DEVELOPMENT REVIEW COMMITTEE (DRC) COMMENT REPORT

PROJECT NAME: Muse Tower (416 NE 1st Residences)

CASE NUMBER: UDP-S22052

REQUEST: Site Plan Level II Review: 112 Multi-Family Residential Units and 854 Square-Foot of Commercial Use in Downtown Regional Activity Center

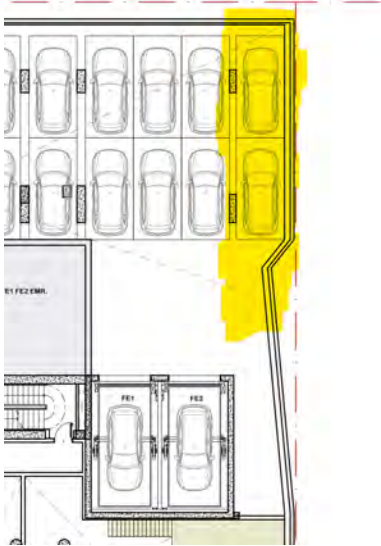
11. Sheet A102M.00 shows a jog in the building in the top southeast side of the building and looks like the vehicles will not be able to access the parking stalls. Please clarify how vehicles will access the parking stalls or make the necessary changes to meet city code drive aisle requirements. See image below.
